UNITED STATES PATENT AND TRADEMARK OFFICE

APPLICATION NO.	FILING DATE	FIRST NAMED INVENTOR	ATTORNEY DOCKET NO.	CONFIRMATION NO.
10/519,471	12/29/2004	Helmut Mertens	47724	2683

Office Action Summary

DETAILED ACTION

Fig. 6. Modified references: C, H and R.

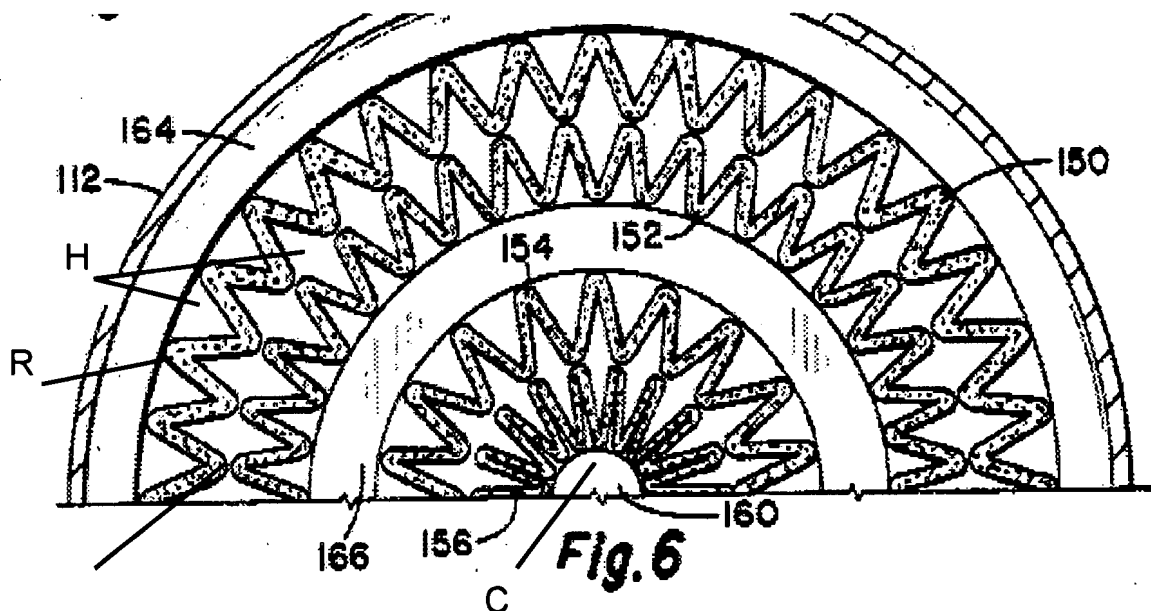
Claim 1. Branchcomb teaches a filter element for filtering fluids having filter unit (150 and 154), being arranged concentrically around its longitudinal axis (Fig. 1 and col. 3 lines 1-4), and having support element (152 and 156) supported in the direction of the throughflow with the fluid stream on the support element (152 and 156).

The support elements (152 and 156) are being provided on their side facing the filter unit (150 and 154) having channels (modified, Fig. 6, H) for fluid guidance.

The channels (modified Fig. 6, H) extending with their longitudinal ribs (modified Fig. 6, R) bordering by the spiral tracks (gaps of helical pleats, Fig. 1, 30 or Fig. 6, 130 and 131) along the support element (modified Fig. 6, s1 and s2),

and the channels (modified Fig. 6, H) having two free ends (along sides on Fig. 6, 114 and 116) emerging on the opposing ends of the support element (152 and 156) extending continuously without repeated deflections of the fluid stream (arrows, Figs. 1 and 5) along the support elements (152 and 156) and only partially encompass the support element (gaps of helical pleats, Fig. 6, 130, 131) with the formation of twisting guides for the fluid flow (arrows, Figs. 1 and 5).

Claim 2. Branchcomb teaches the support elements (152 and 156) being formed from a support tube (modified Fig. 6, s1 and s2 and core tube, Fig. 3, and col. 3 lines 66-67), and wherein the channels (modified Fig. 6, H) bordering laterally by the projecting longitudinal ribs (modified Fig. 6, R) of the support tube.

Clam 3. Branchcomb teaches the channels (modified Fig. 6, H) being located both on the inner and outer peripheral side on the support tube (modified Fig. 6, s1 and s2).

Clam 7. Brancomb teaches the fluid stream may flow through the innermost and the outermost filter unit (modified Fig. 6, 164 to H), from the outside (150) to the inside in the direction to the clean side of the filter element (156 and Col. 1 lines 44-49), and wherein flow is incident on the filter unit (10a, 10b and 10c), lying in between and from the two sides, to the inside and outside (modified Fig. 6, 10a to 160 or 114 to 116).

Claim 10. Branchcomb teaches 20 channels (modified Fig. 6, H) being located on one of the support elements (150) forming a common fluid guide, having a tilt of the twisting guide between 10° to 30°, preferably 15° (approximate visual angle on Fig. 1, 30 or helical pleats), relative to the axis which is parallel to the longitudinal axis of the filter element (150, 152, 154, 156 and Fig. 1 and col. 3 lines 1-4).
